Platt Technical High School

ADDENDUM NO. 4

August 9, 2019

1 MEDIA CENTER - SOUTH
1/4" = 1'-0"

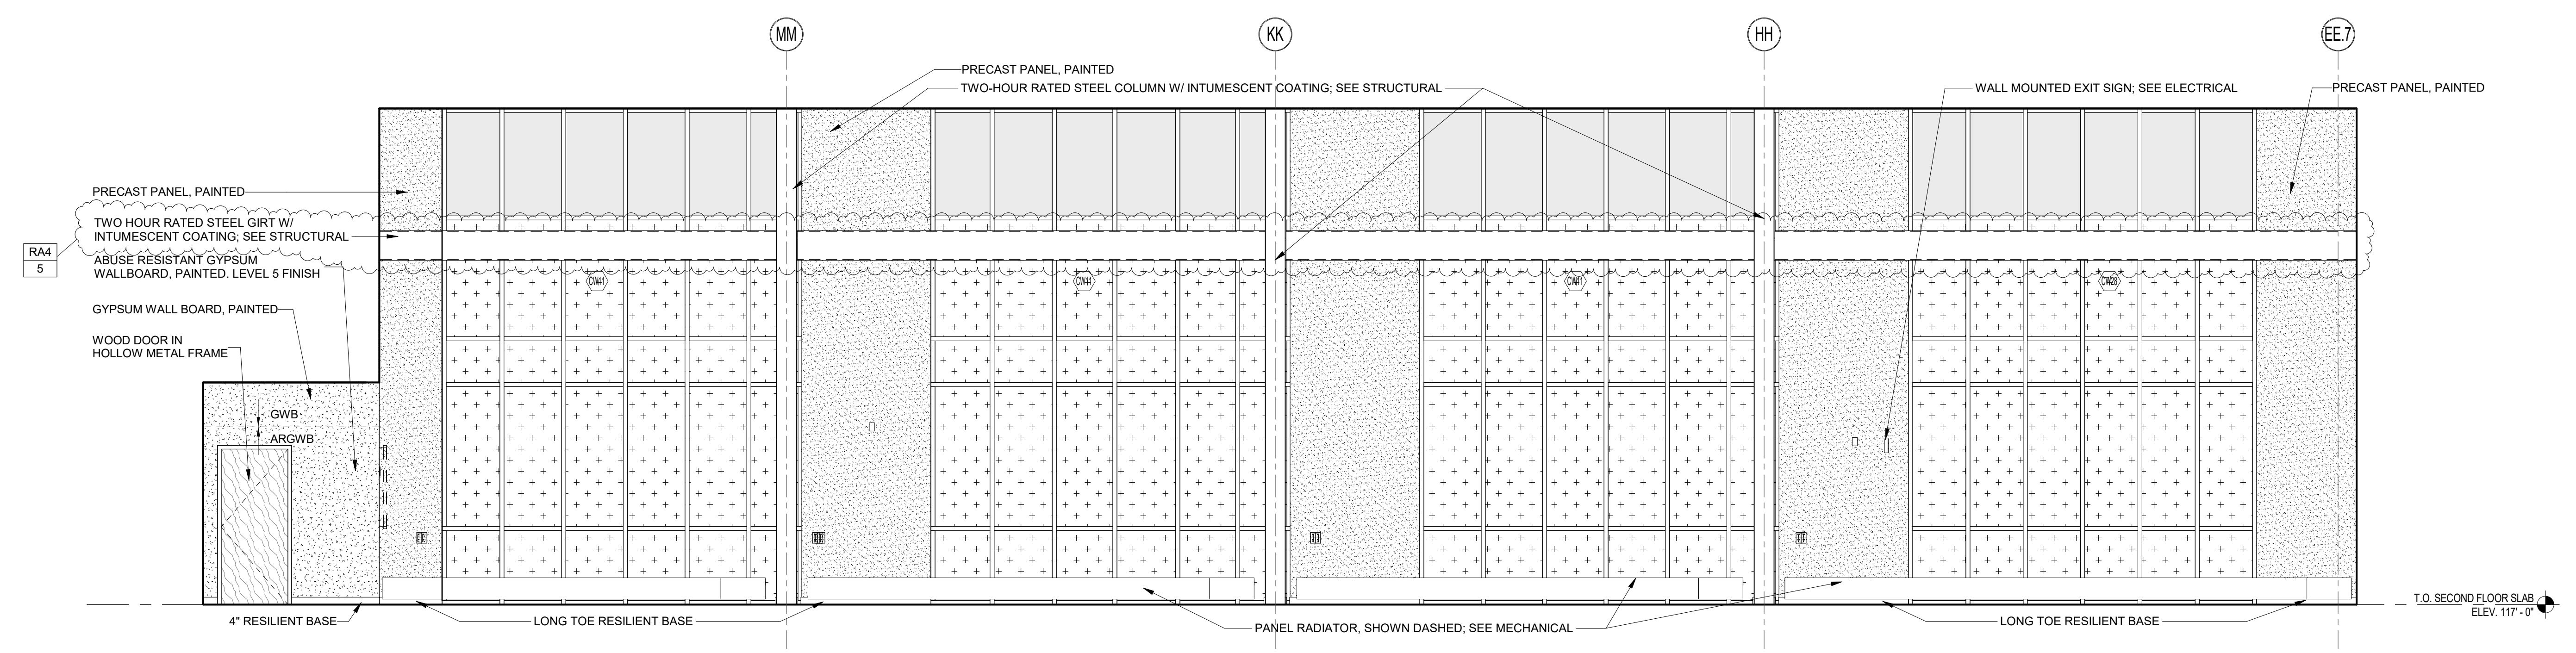
- ADD 4-071** **A2-2-1 – INTERIOR ELEVATIONS**
Interior Elevation 5: Revised Aluminum Frame Tags per Revision Sketch RA4-04.
- ADD 4-072** **A2-2-3 – INTERIOR ELEVATIONS**
Interior Elevation 1 and 2: ADDED Structural Steel Girt, with intumescent coating, per Revision Tag RA4-5

date 05/24/2019
scale As Indicated
drawn by Author
approved by Approver
drawing no. **A3-2-10**

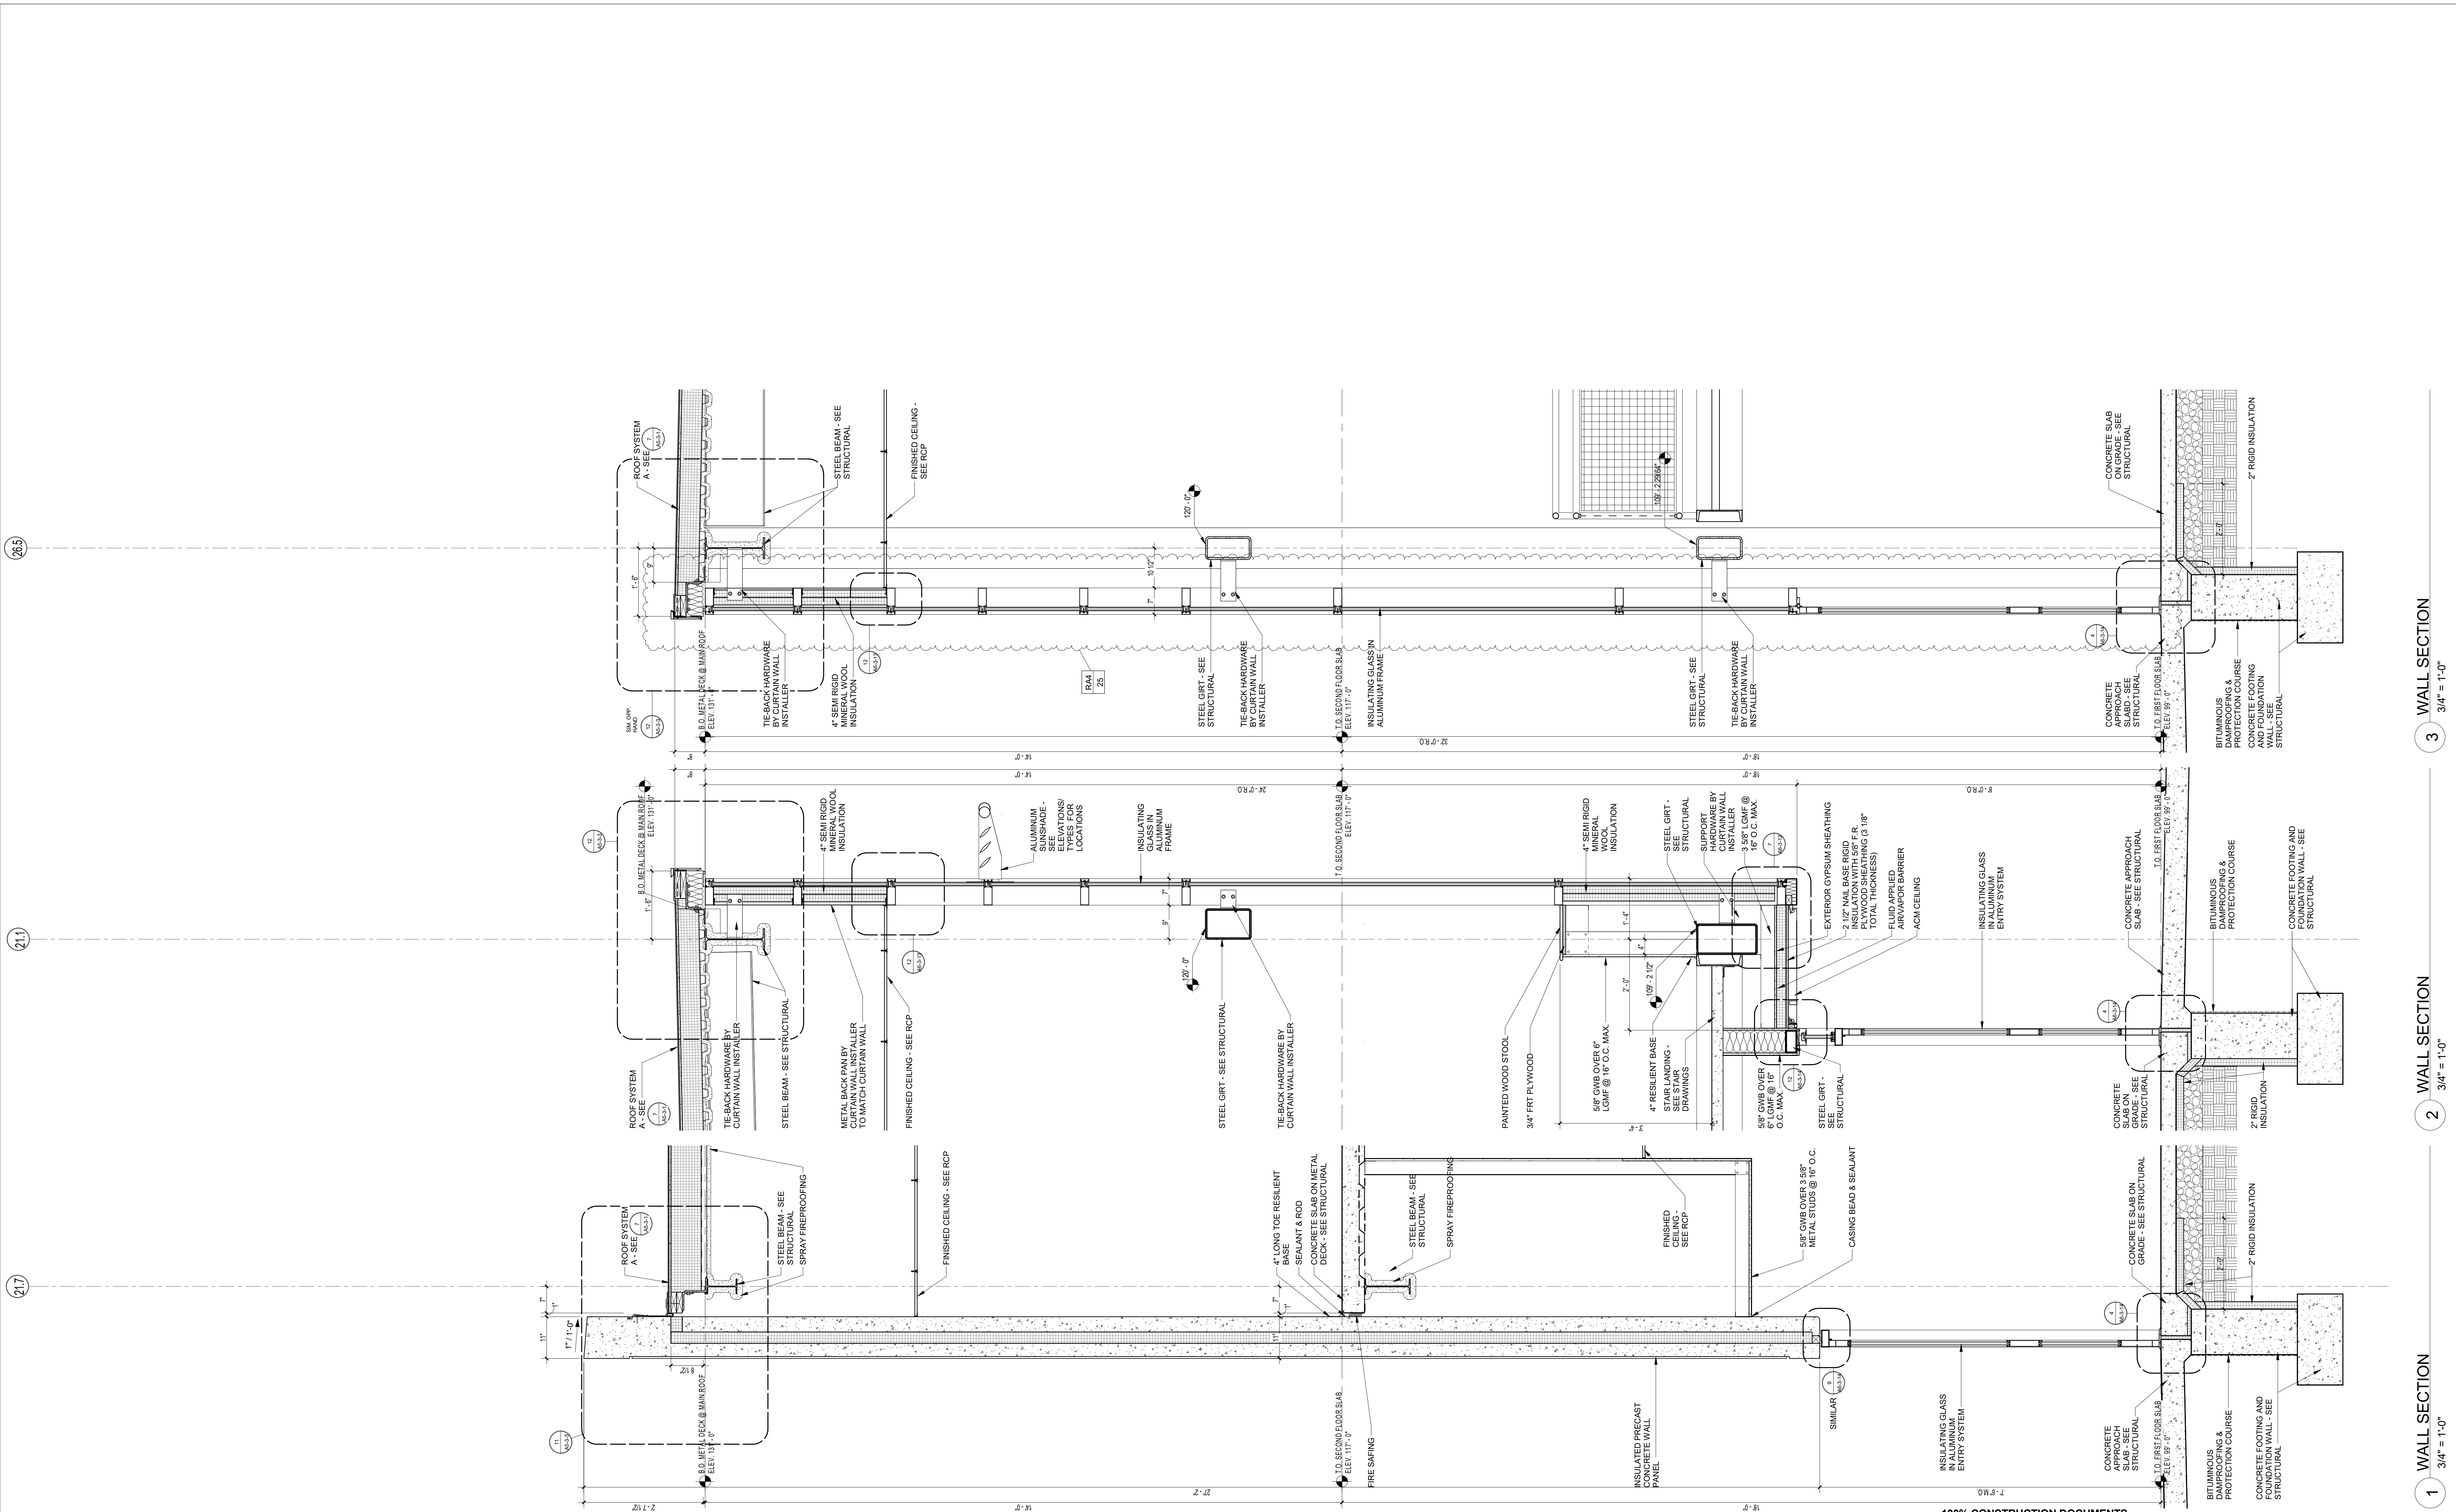
- ADD 4-080** **A3-2-5 – WALL SECTIONS**
Section 1: Added structural girt per Revision Sketch RA4-31.
- ADD 4-081** **A3-2-10 – WALL SECTIONS**
 Section 1: ADDED Structural Steel Girt, with intumescent coating, per Revision Sketch RA4-24.
 Section 2: ADDED Structural Steel Girt, with intumescent coating, and REVISED Aluminum Frame detailing per Revision Sketch RA4-24
 Section 3: ADDED Structural Steel Girt, with intumescent coating, per Revision Sketch RA4-24
